# City of Alexandria, Virginia

## MEMORANDUM

**SUBJECT:** 2<sup>nd</sup> CONCEPT REVIEW OF 101 DUKE STREET  
BAR # 2020-00612

2 TH 2 GRADING SECTION  
 1/8" = 1'-0"

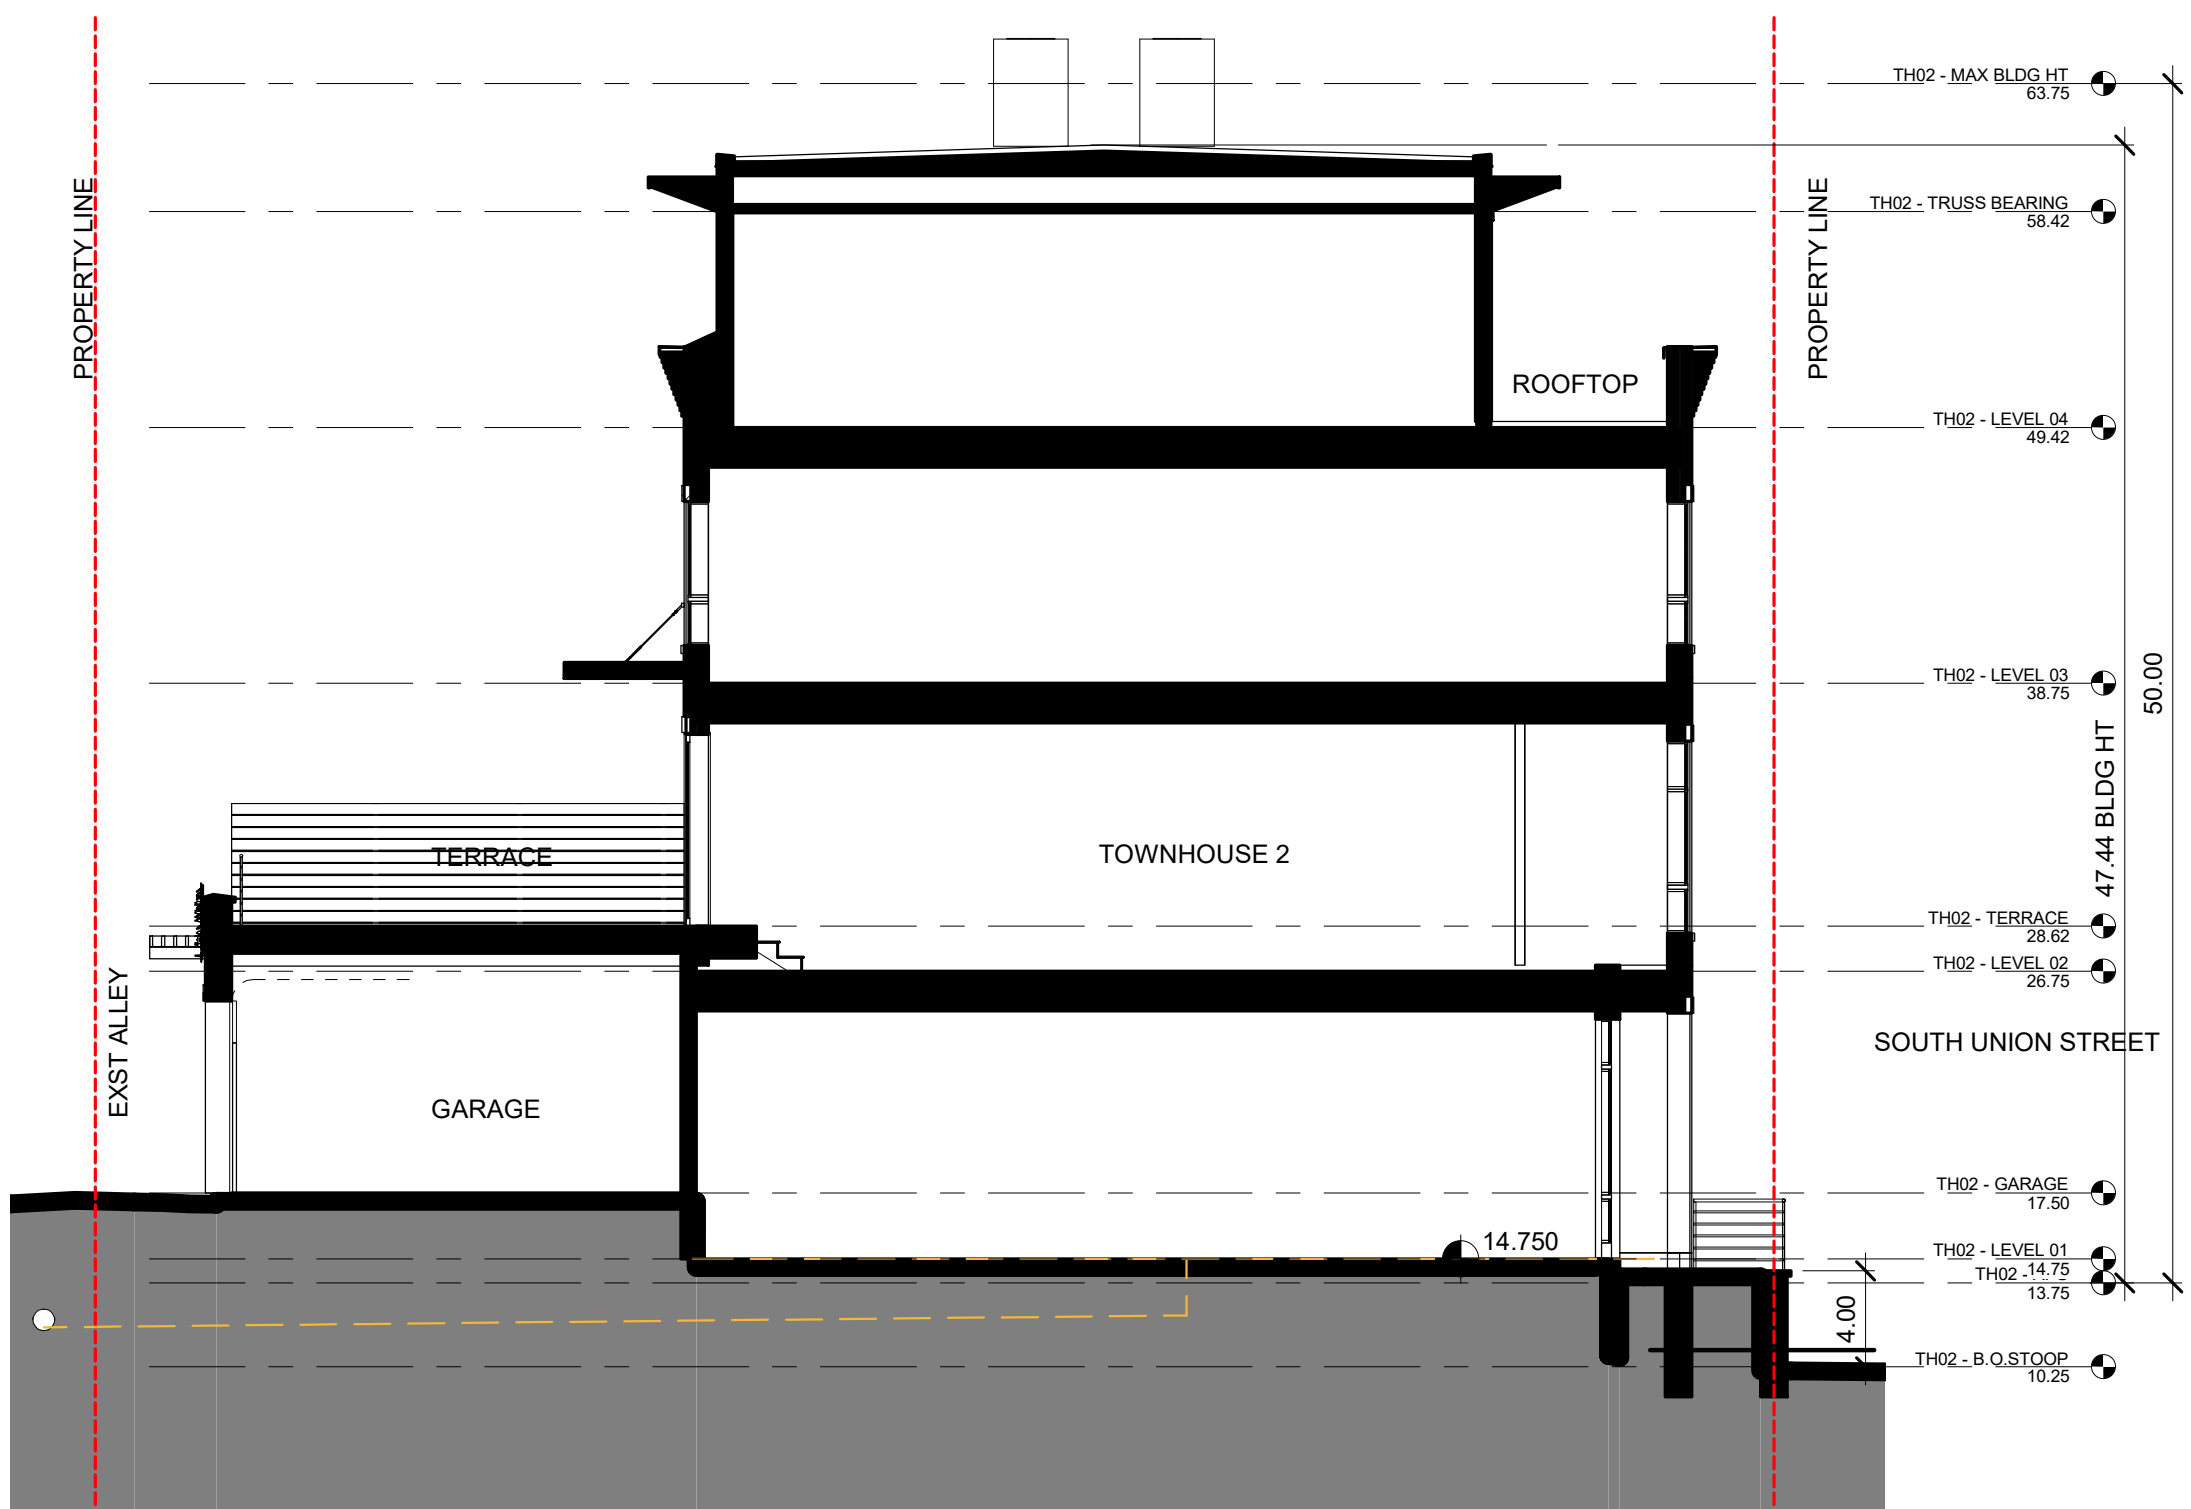
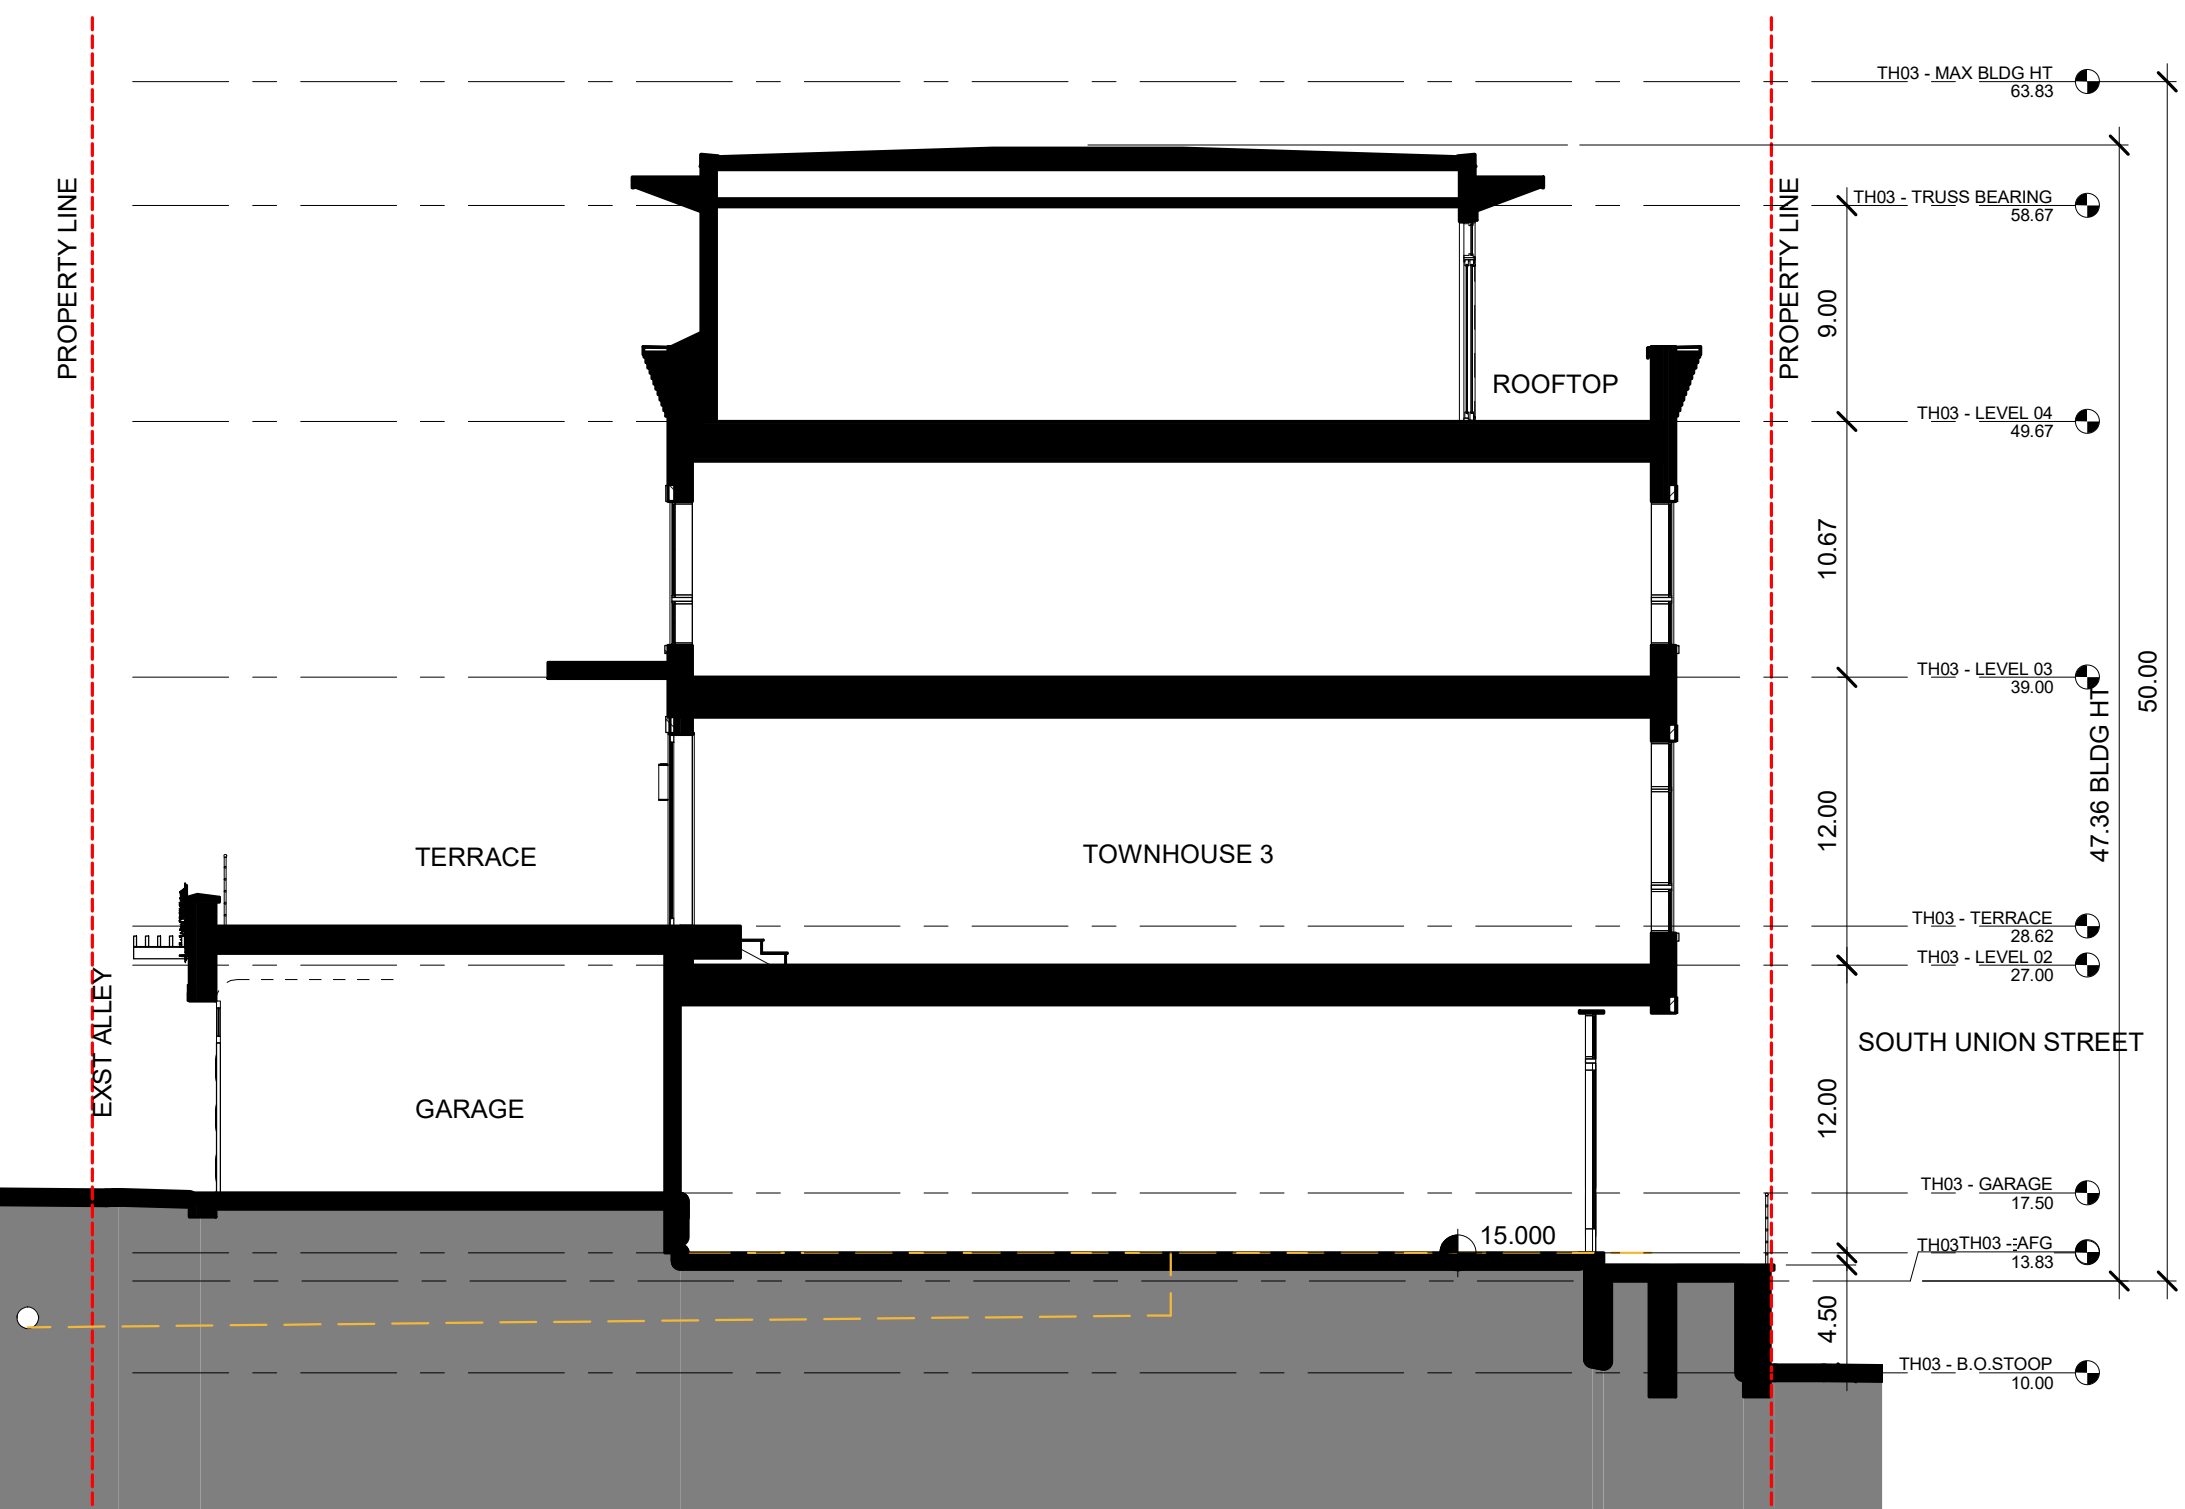
The previous design included entry stoops that ranged in height above the Union Street sidewalk from 5' at the lowest point to 7' at the highest point. As was discussed at the previous hearing, Union Street is a vibrant pedestrian oriented street and the height of the entries made for an uncomfortable relationship with the sidewalk. The design team was able to modify the interior design for the building so that the height of the stoop is not entirely driven by the elevation of the garages at the rear of the site. Unfortunately, there are other existing site conditions that require an elevated entry for each of the townhomes. In the revised design the applicant is now achieving entry stoop heights that range from 3' at the lowest point to 6' at the tallest. These create a streetscape that is much more friendly to pedestrians and brings the living spaces closer to the level of the sidewalk.

The current design for the entry stoops shows brick walls with brick pavers and metal rails. While the height of the stoops above the adjacent grade has improved since the last submission, the current design is still somewhat imposing and monolithic. This element represents an opportunity to create a part of the building that engages the sidewalk and helps to bring the scale of the building to a more pedestrian level. It is quite common throughout the historic district to find entry stoops in a variety of different designs. In some cases, where there is an English basement configuration, the entrance to the basement apartment is through stairs below the entry. Staff suggests that the applicant consider options for the design of the entry stair that are similar to those found throughout the historic district (Figure 12). In addition, it may help to provide a variation of approaches based on the height of the stoop which will further serve to break up the overall massing of the building.
